Our ref: 09123
18 February 2013

Joint Regional Planning Panel (Sydney East)

RE: 2012SYE092 – Leichhardt - D/2012/429 - Demolition, remediation, mixed use development (residential, retail & industrial), parking, new road, sales office /display units, signs & subdivision - 118-120 Terry Street, Rozelle

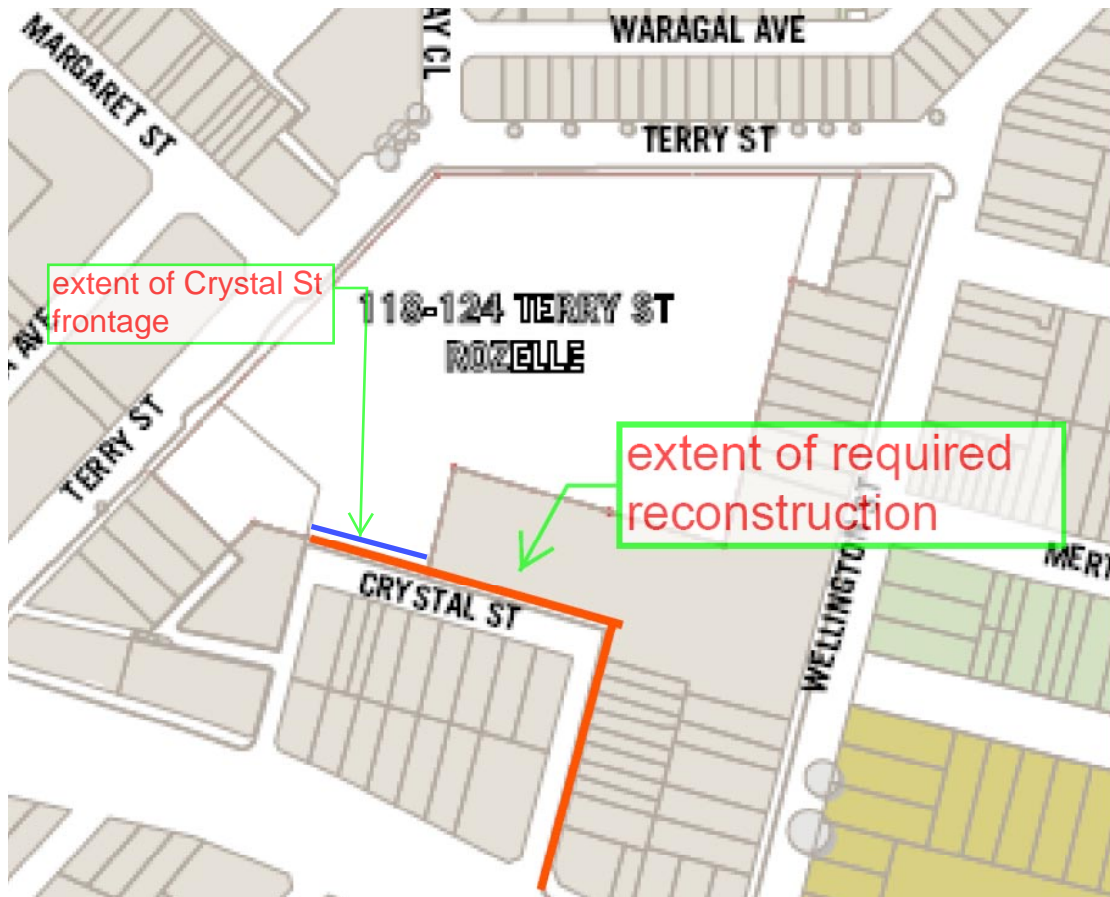
"Reconstruction of the sandstone kerb, concrete gutter and asphalt footpath at the Crystal Street frontage and extending on that side of the road to the southern eastern intersection of Crystal Street with Victoria Road, except where deemed by Council to be in very good condition. Note that this will also require the reconstruction of existing vehicle crossings."

The extent of reconstruction potentially required by the above is shown in the diagram below.

It is inappropriate and unnecessary for this development to have to reconstruct any kerb and footpath that is beyond the site frontage. Accordingly this part of the condition should be modified to only refer to the Crystal Street frontage.

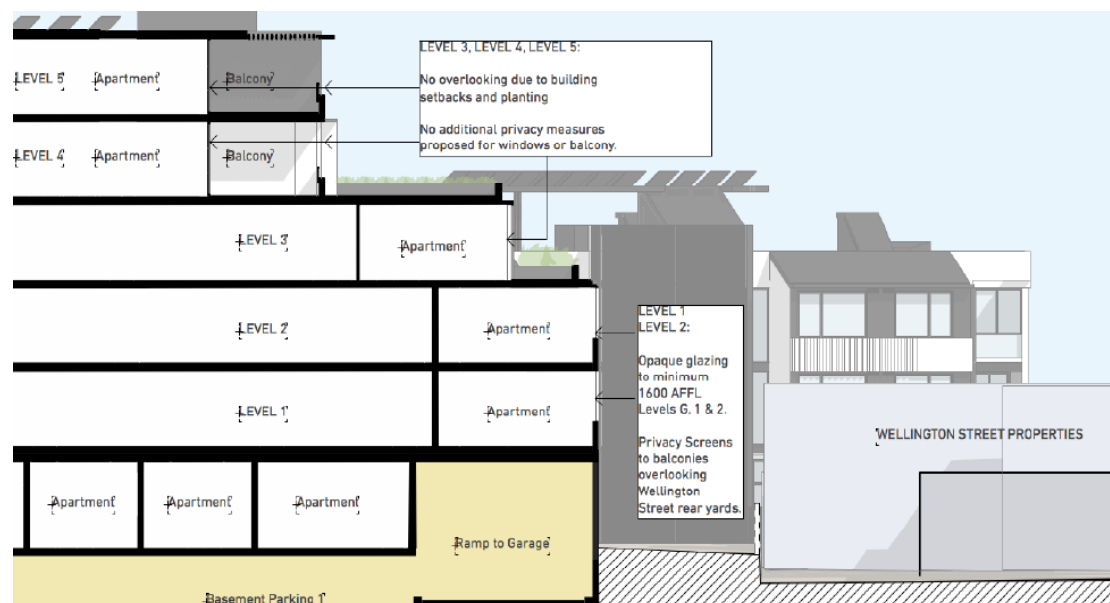
We believe that these requirements are only intended to apply to Levels 1 and 2 of Building B as there are no openings in Building A and Levels 3, 4 and 5 of Building B are stepped back in a manner that inhibits overlooking (see diagram below).

Also overlooking from ground level will not be possible due to landscaping and fencing.

Accordingly Condition 41 should be amended to insert the following words between the words "windows" and "directly", and in Condition 42 between the words "terrace" and "which": "in Levels 1 and 2 of Building B".
